**2-6 Lisgar St – Rezoning – Request for Direction Report**

<b>Date:</b>	December 10, 2008
<b>To:</b>	Toronto and East York Community Council
<b>From:</b>	Acting Director, Community Planning, Toronto and East York District
<b>Wards:</b>	Ward 18 – Davenport
<b>Reference Number:</b>	07 268078 STE 18 OZ

Attachment 1: Ground Floor Plan

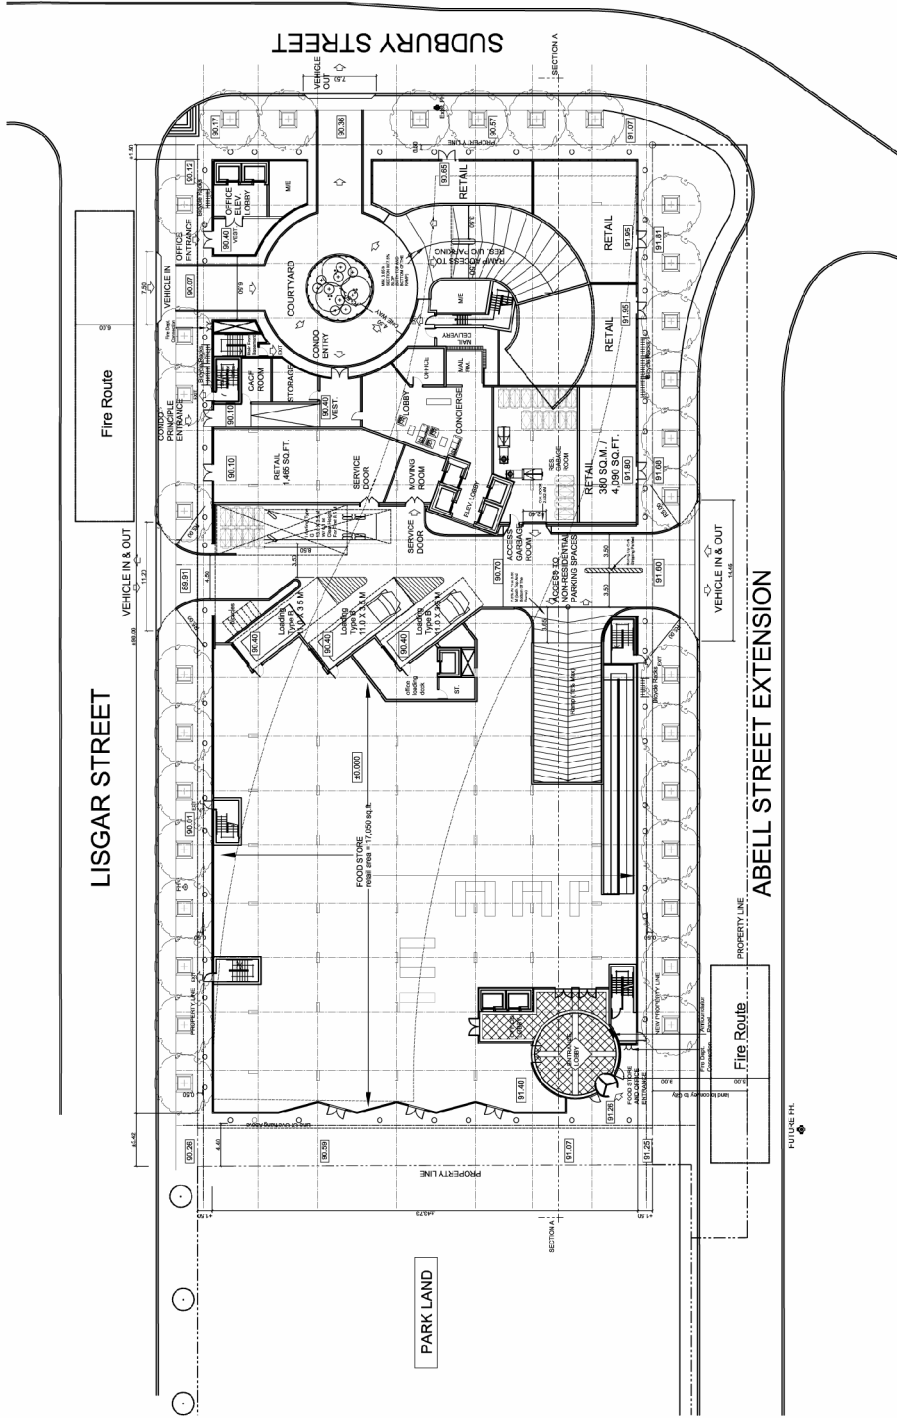
As this building will be surrounded by streets on 3 sides it is important that all the facades contribute to the animation of the streets. While there are smaller retail units proposed along Sudbury Street and Abell Street (at the south end) it is unclear as to how the outdoor edges of the grocery store will provide animation to the street.

- The applicant needs to provide additional details as to how the ground floor façade will be treated, be it with public art or smaller retail shops, for staff to assess.

- The applicant needs to provide a plan to clearly show the way that the interior space, directly accessed from the park will be used. Staff would like to see active uses which can spill out into the park to create a lively dynamic between the park and the building.

Attachment 2: Third Floor Plan

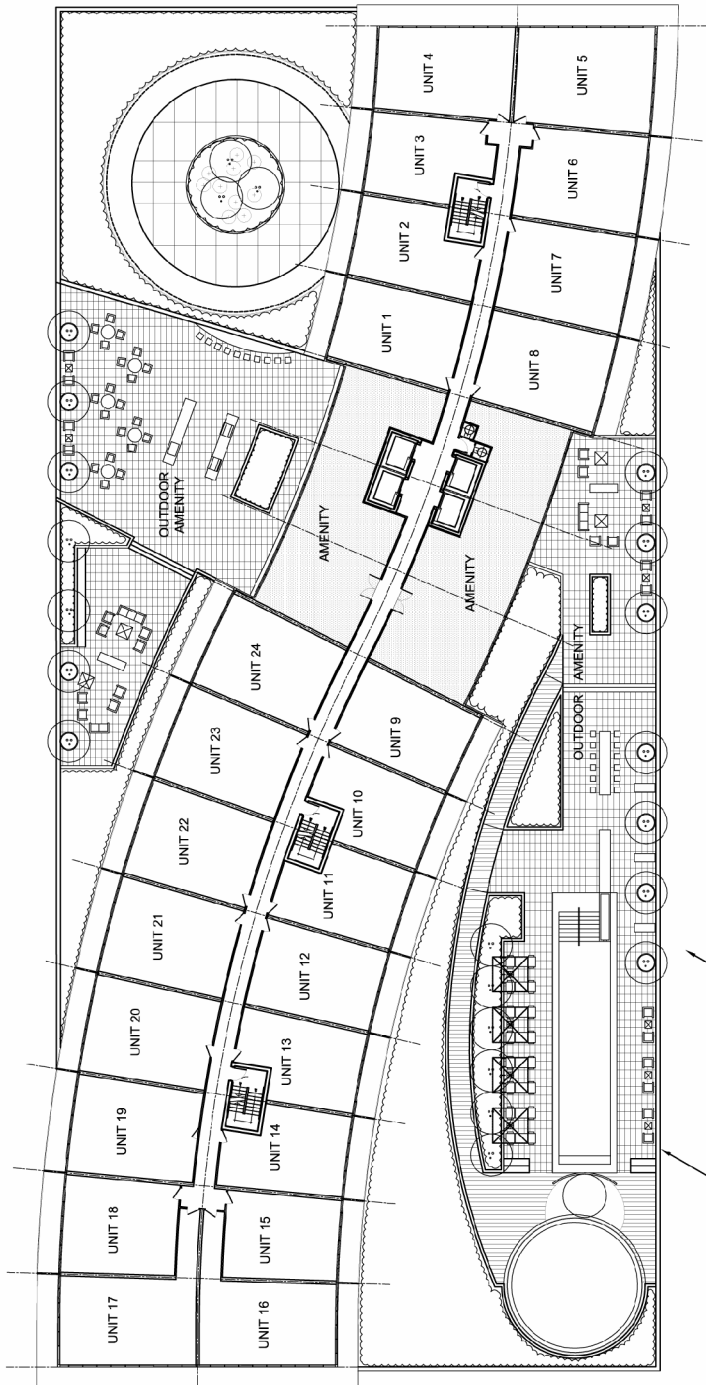
The applicant is proposing 1.5 square metres per residential unit of indoor and outdoor amenity space which is acceptable. The indoor space is not all contiguous which is appropriate given the location of the outdoor space on top of the 2-storey podium, on either side of the tower. However, it is not clear as to where the washrooms and kitchens are located.

- Each amenity space must have direct access to a washroom and a kitchen should be included in any indoor space which is adjacent to an outdoor space.

Attachment 3: West Elevation

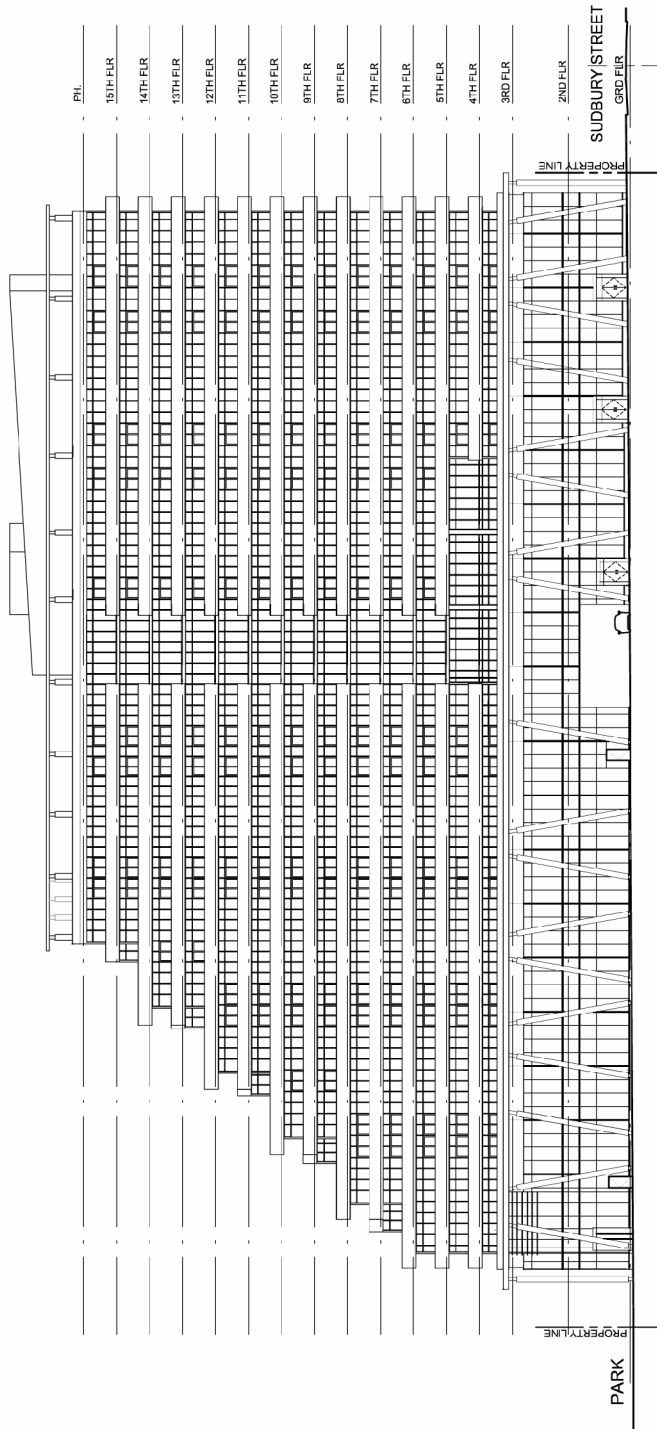
The total height of the building according to the measurements on the latest drawings is 50 metres to the top of the residential floors, with a 5.2 metre tall penthouse for mechanical equipment and amenity space on the roof. The total height for the first 15 levels (50 metres) is acceptable.

- The amenity space on the roof must be removed and the mechanical space cannot be higher than 3.5 metres (including all elevator overruns, stair towers, equipment etc.).
- The mechanical space should be located on the southern portion of the roof, it cannot occupy more than 40% of the area of the roof and should be set back from all roof edges.

The current design of the building locates the tallest massing towards Sudbury Street and steps down towards the park.

- The amount of stepping must be increased thereby reducing the shadows on the park.
